WADP 2010 1079  
4731 ESSEX AVE, SOMERSET  
PRELIMINARY CONSULTATION

Staff Item  
4731 Essex Avenue, Somerset  
Anne Fothergill

Subject: 4731 Essex Ave. – Pieczenik Residence

# SITE PLAN

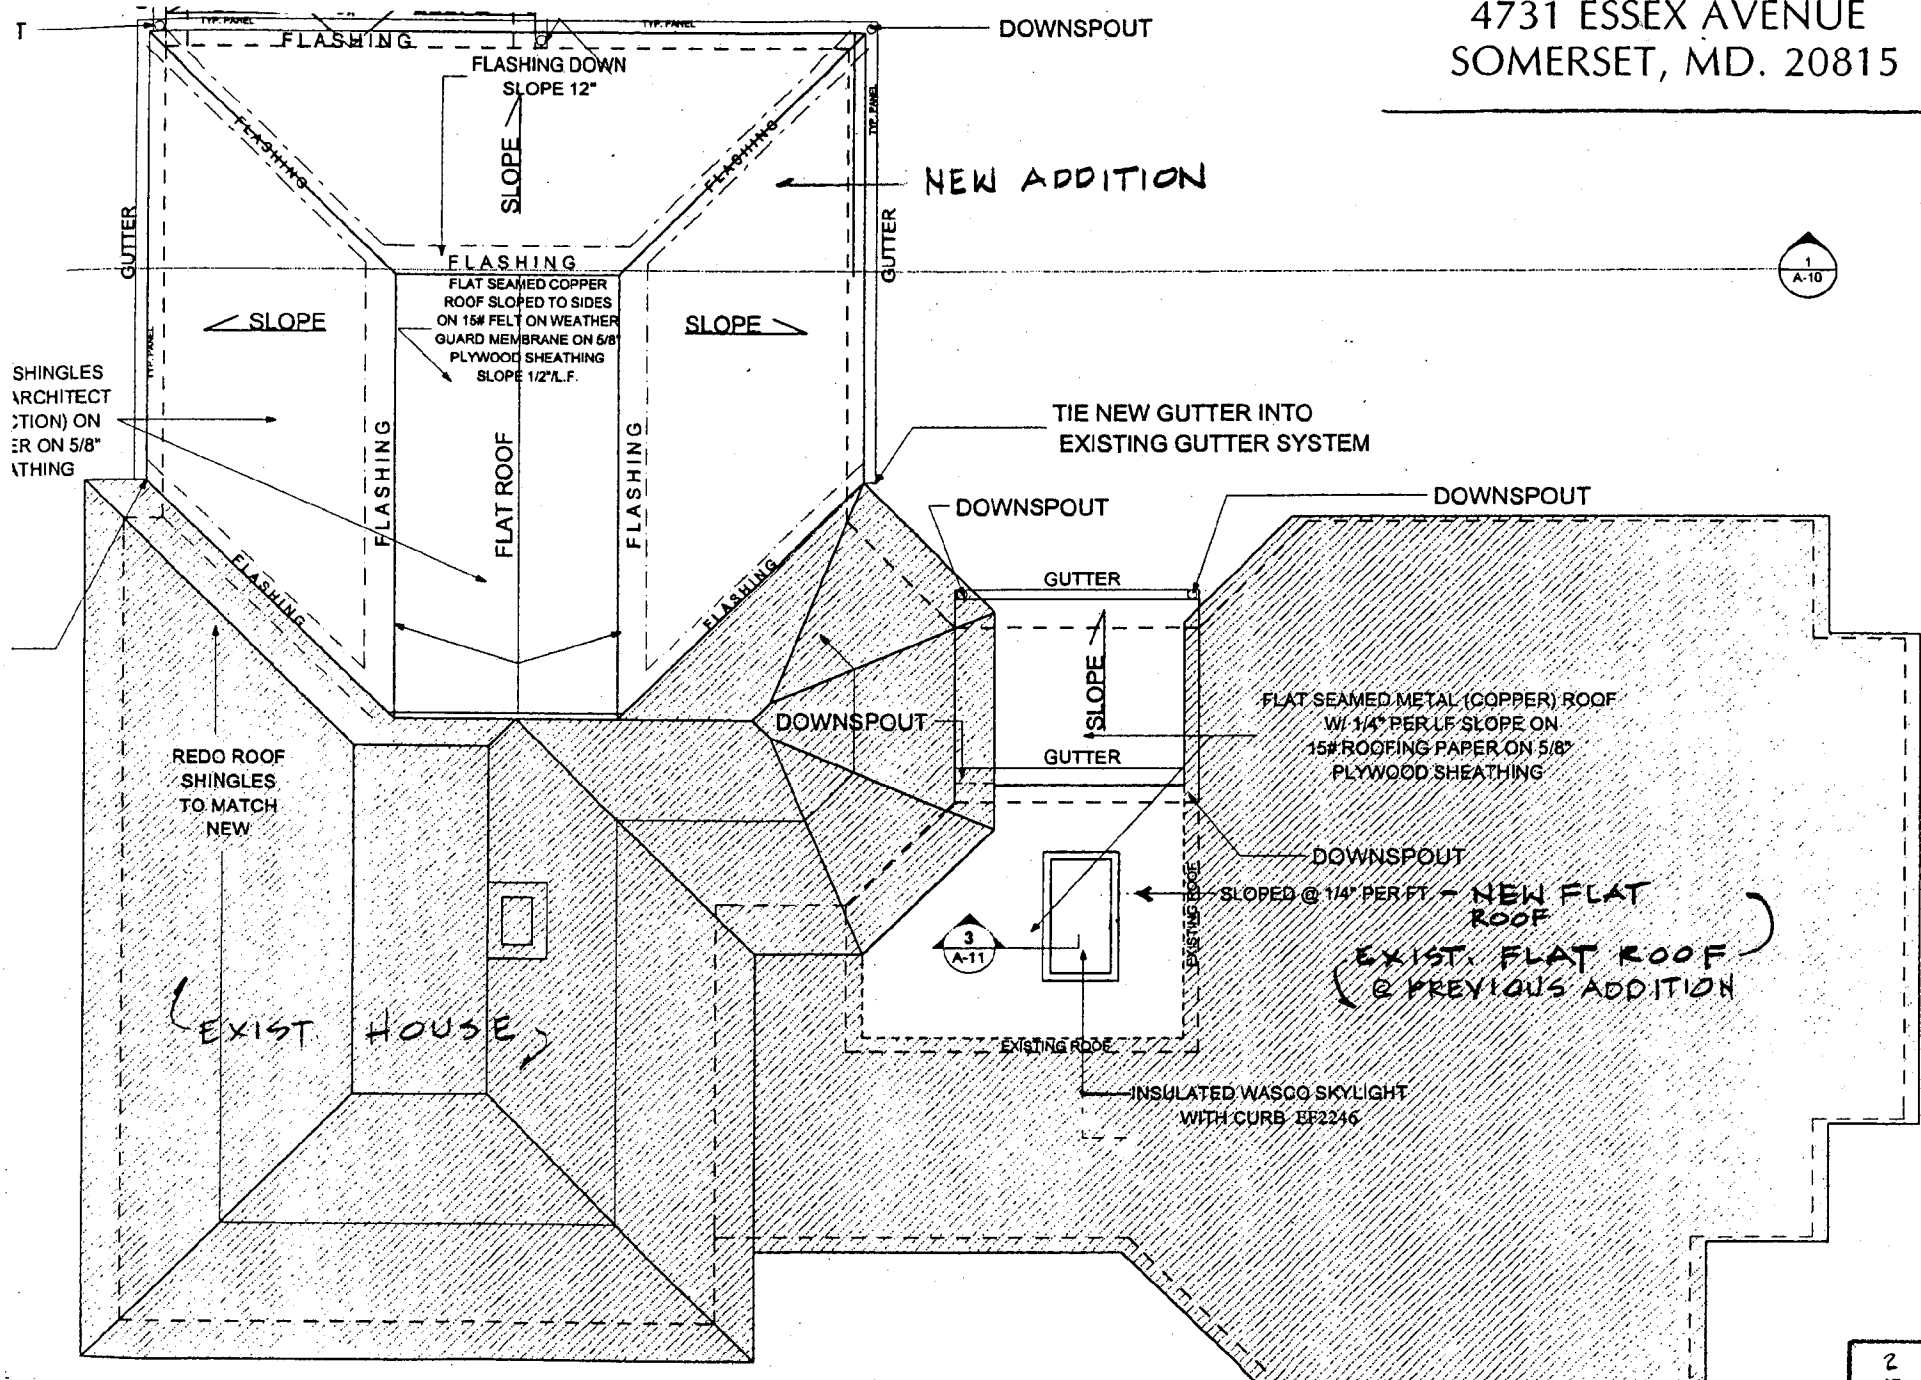
- 1) Install a flat skylight on the flat roof of the new addition
- 2) Install flagstone walkways to the new back porch and patio
- 3) Replace the windows in the 1970s side addition with metal windows to match existing windows

NEW FLAGSTONE  
SIDEWALKS SET IN STONE DUST,  
TO MATCH EXIST. STONE WALK & FRONT YARD

ROOF PLAN

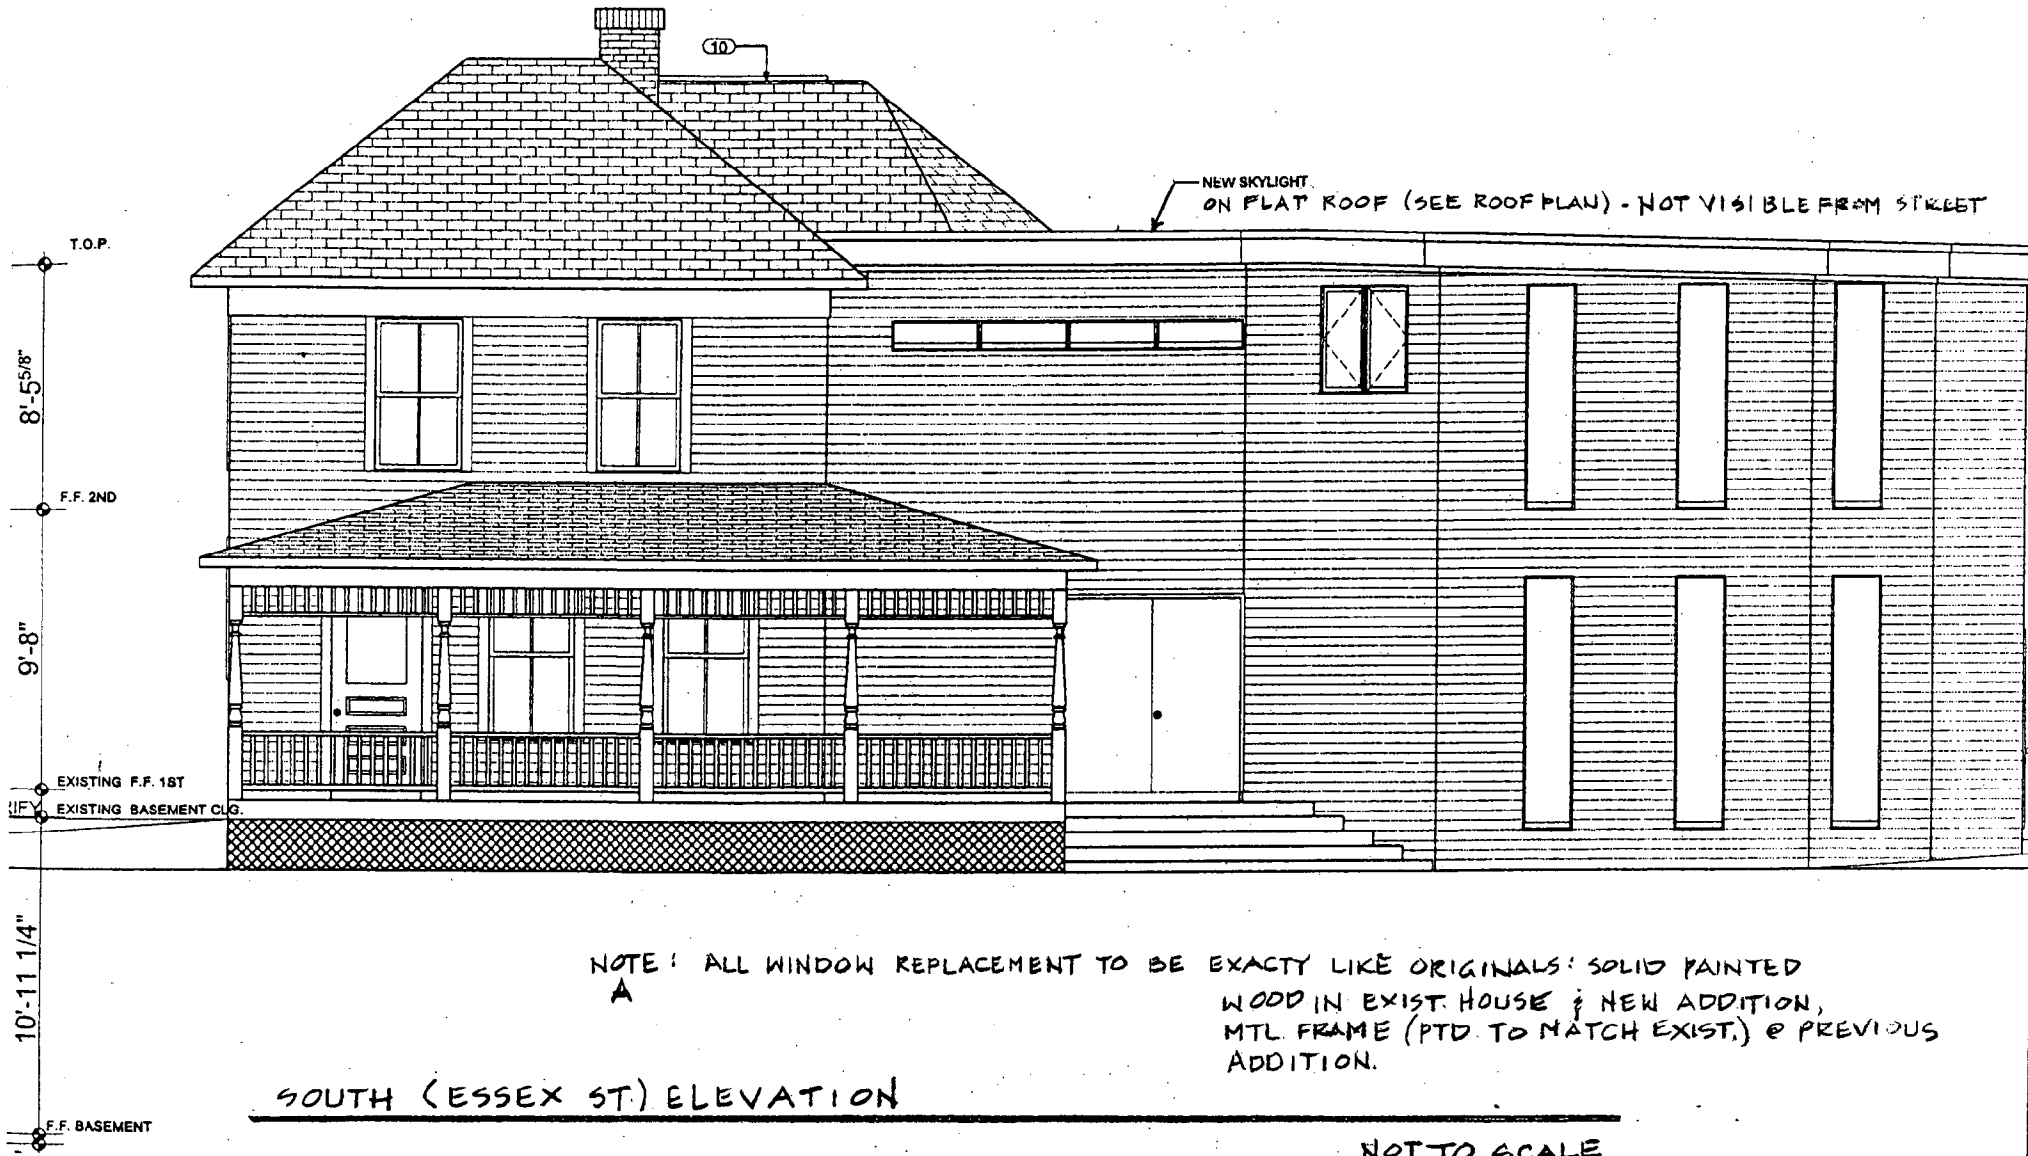
NEW SKYLIGHT ON FLAT ROOF (SEE ROOF PLAN) - NOT VISIBLE FROM STREET

SOUTH (ESSEX ST.) ELEVATION

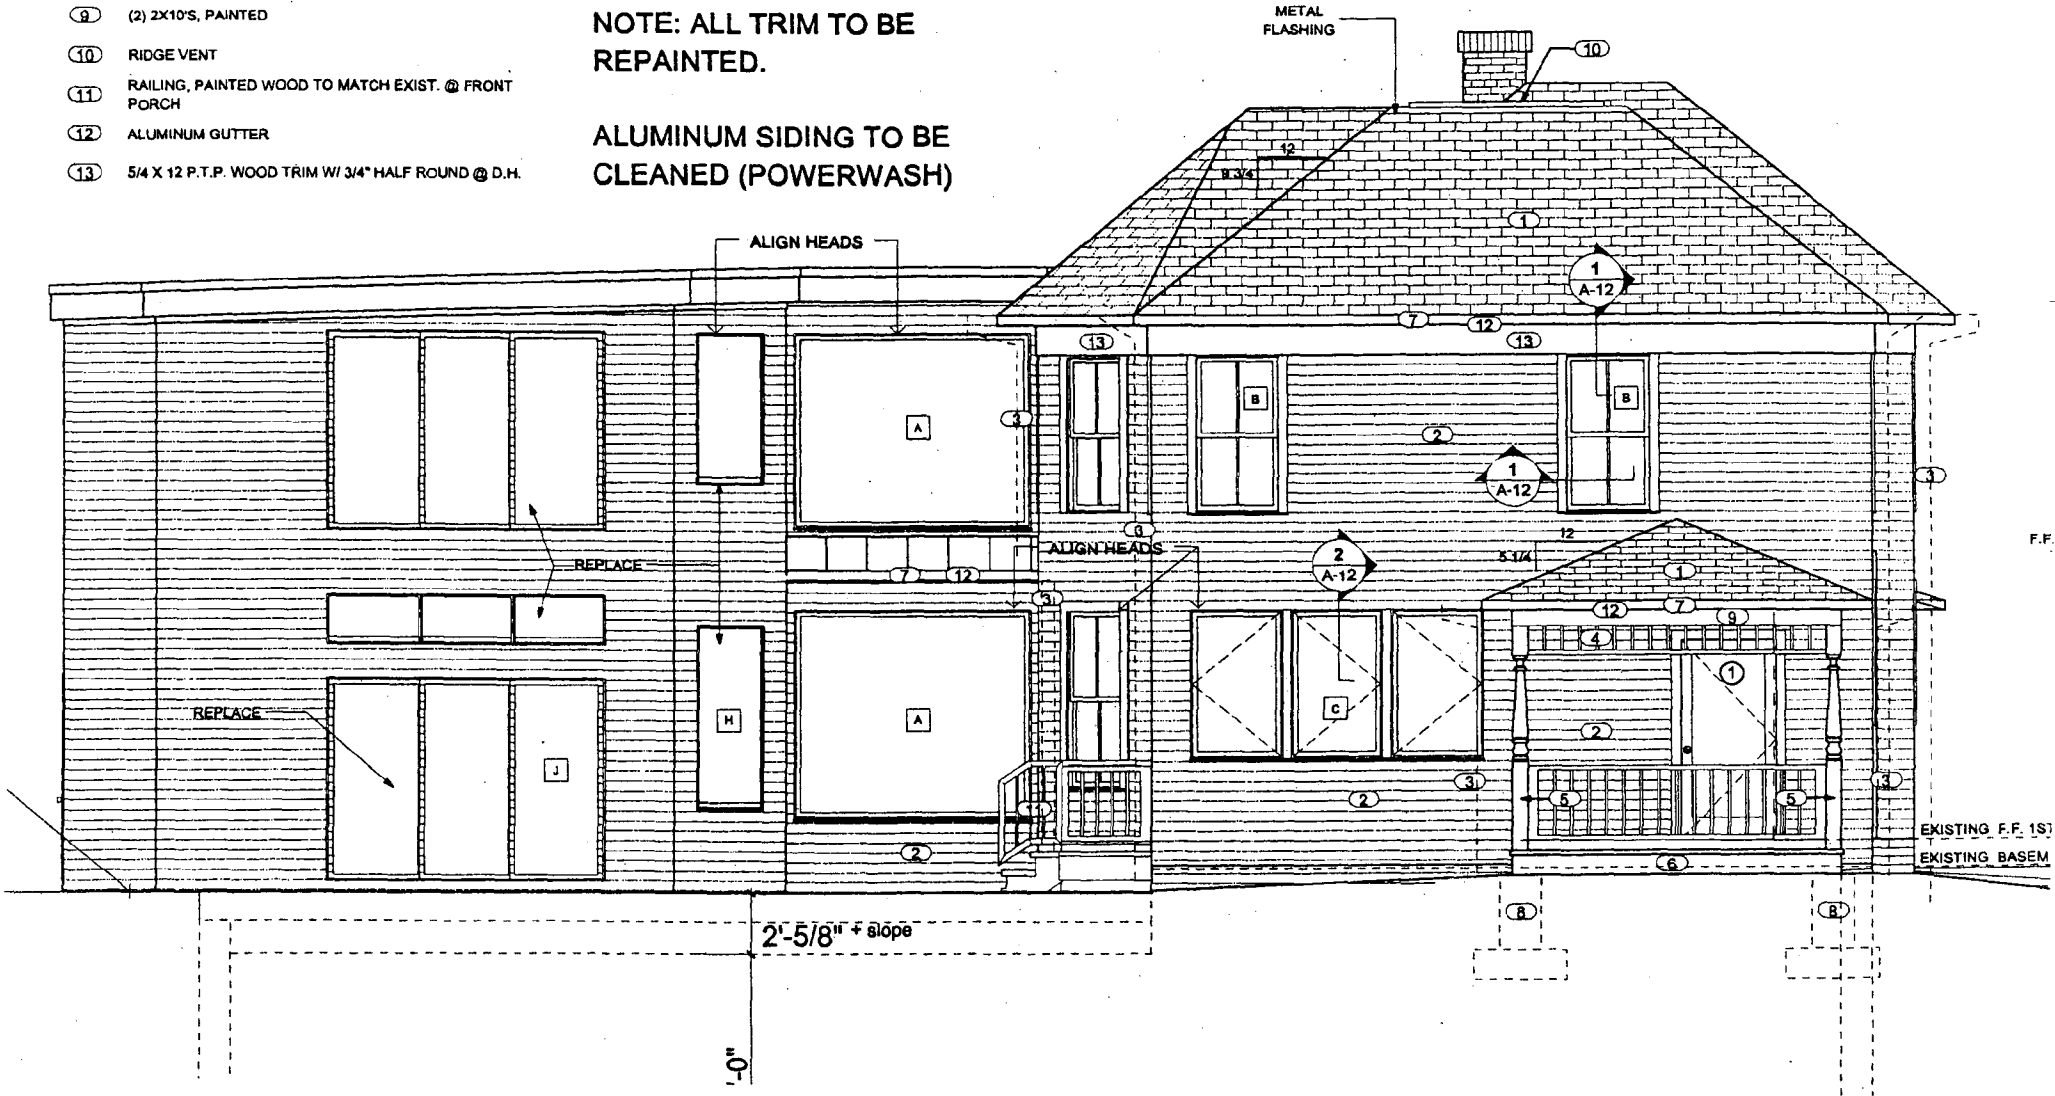
NOTE: ALL WINDOW REPLACEMENT TO BE EXACTY LIKE ORIGINALS: SOLID PAINTED WOOD IN EXIST. HOUSE & NEW ADDITION, MTL. FRAME (PTD. TO MATCH EXIST.) @ PREVIOUS ADDITION.

KEY PLAN: TREE PRESERVATION RECOMMENDATIONS

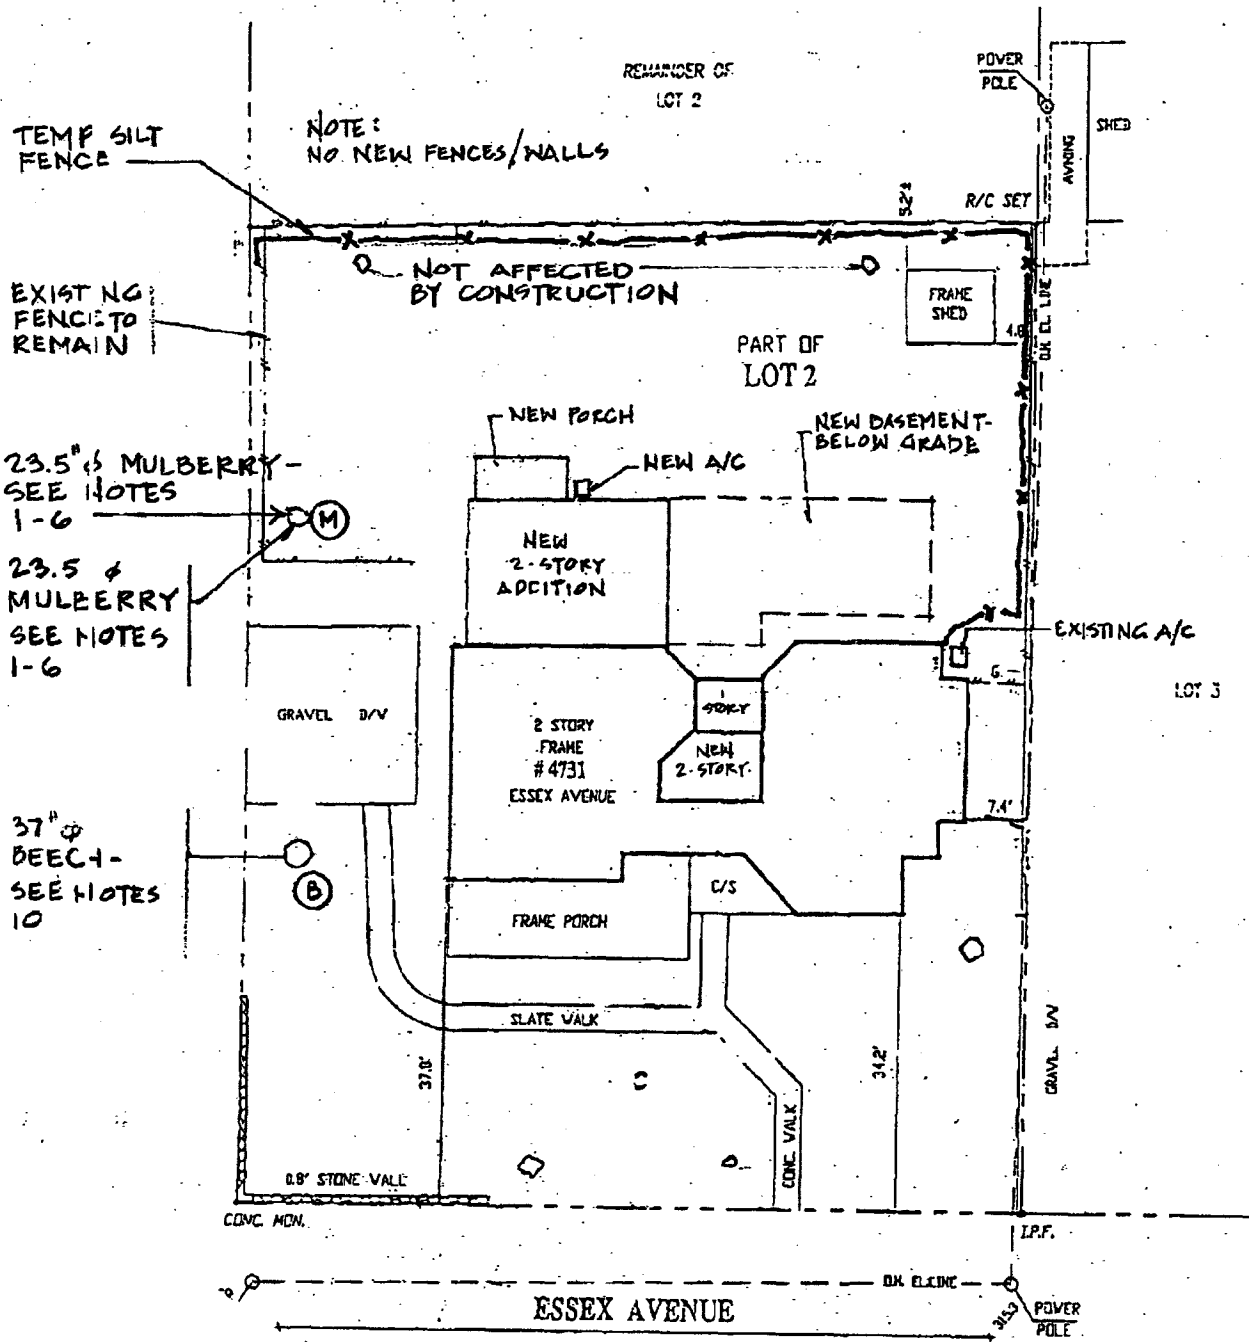
1. **Root Pruning** - Mulberry tree 23.5" in diameter located at rear left. TCOT will provide a crew led by an ISA Certified Arborist to Root Prune 18-24" deep along the area at the rear left corner of the house by using a mechanical root pruner with hand pruning of roots  $\geq 1$ " diameter. Root pruning is a stress reducing process whereby roots are cleanly cut to allow rapid callous tissue development over exposed root tips.

**Cost \$350.00**
2. **Tree Protection Fencing** - TCOT will provide a crew led by an ISA Certified Arborist to install 4', Welded Wire fence, set with 6' T-Posts on 10' centers around the 23.5" in diameter Mulberry located at rear left, Beech tree 15" in diameter located at rear left border and the Norway maple 16" in diameter at rear right. Yellow Tree Conservation Area Signs and orange flagging will then be attached to the fence at 20-30' intervals.

**Cost \$465.00**
3. **Root Protection Matting** - TCOT will provide a crew led by an ISA Certified Arborist to install RPM in the critical root zone of the Mulberry which will be the main access route during the proposed renovation project. The purpose of the RPM is to provide an artificial air gap under proposed grade fills, sidewalk sections, driveway, roads, etc which allows proper atmospheric gas exchange to occur between fibrous roots and the surface air. The matting will also help distribute the weight of equipment traffic and help prevent soil compaction.
